Subject: RATTLE NOISE FROM INSTRUMENT PANEL AND/OR CREAK NOISE FROM A-PILLAR OVER ROUGH / BUMPY ROADS	Bulletin No: 09-002/14
	Last Issued: 01/08/2014

- This bulletin supersedes the previous bulletin 09-009/12 issued 03/09/12, 07/03/12 and 08/02/12. The APPLICABLE MODEL(S)/VINS, DESCRIPTION, REPAIR PROCEDURE and WARRANTY INFORMATION have been revised.
- Changes are noted below in Red beside the change bar.

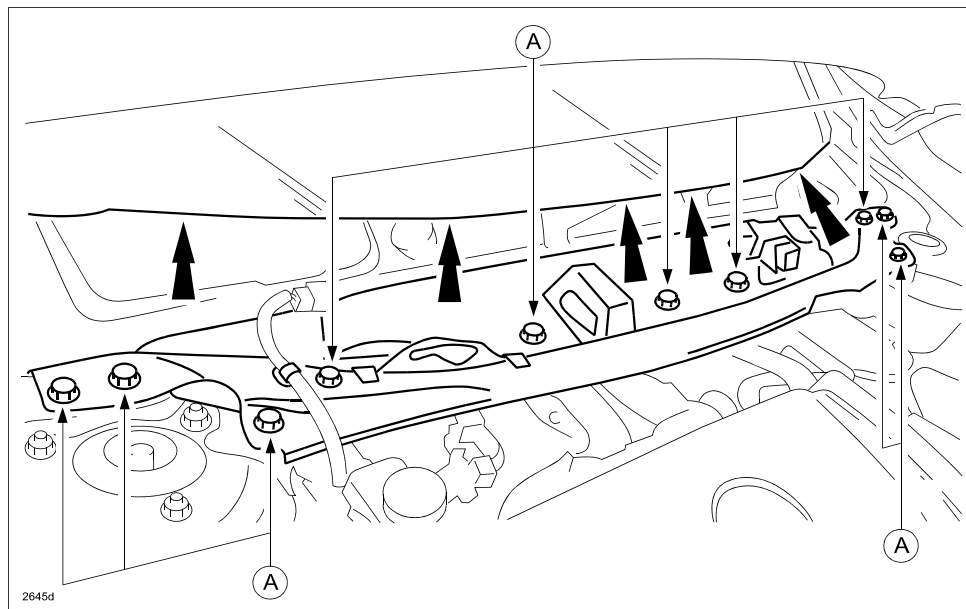
2. Retighten all ten (10) cowl panel bolts (A) to:
Tightening Torque: 17-22 ft. lbs {22-30 Nm, 2.3-3.0 kgf-m}
3. Reinstall the cowl grille according to the online MS3 instructions or the Workshop Manual (section 09-16 COWL GRILLE REMOVAL/INSTALLATION).

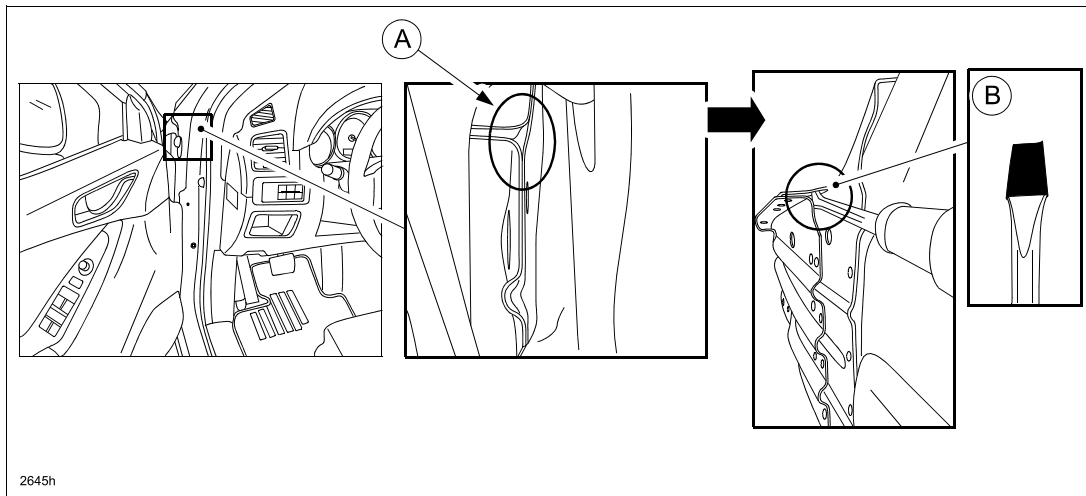
4. Open the front door and place a flat-blade screwdriver with protection tape on the tip (B) between the two panels at joint (A).

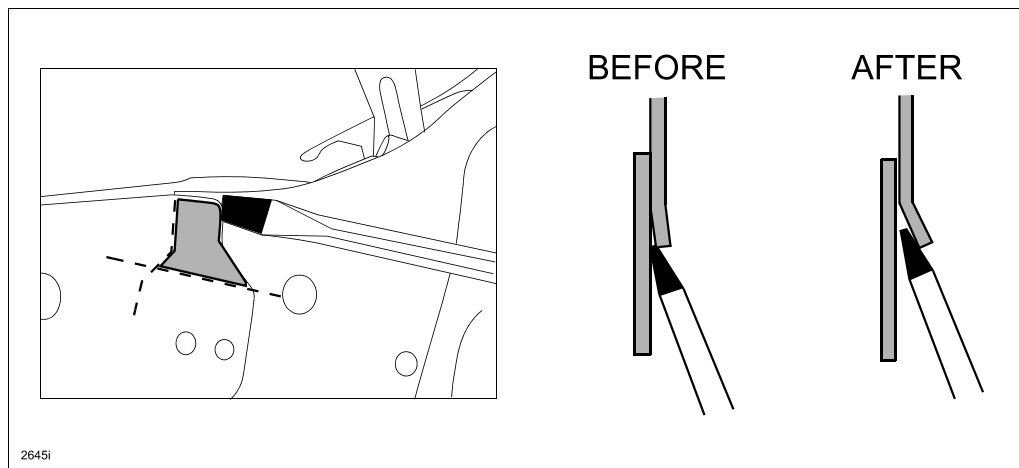
5. Bend the cowl side reinforcement panel (A) to create a clearance of more than 1 mm between the panels.

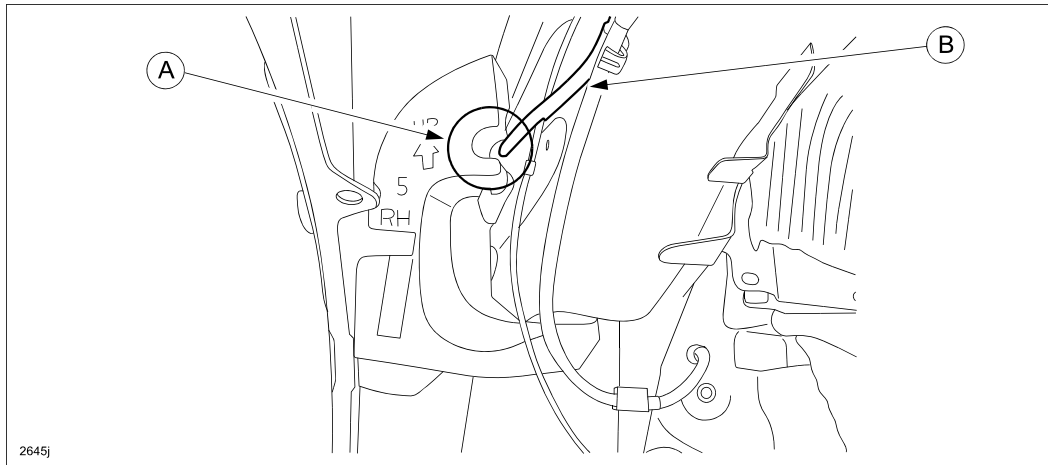
NOTE: Passenger Side Only: When reinstalling the cowl side seal plate, make sure to install the rear window washer hose (B) in the opening (A) to avoid hose damage.
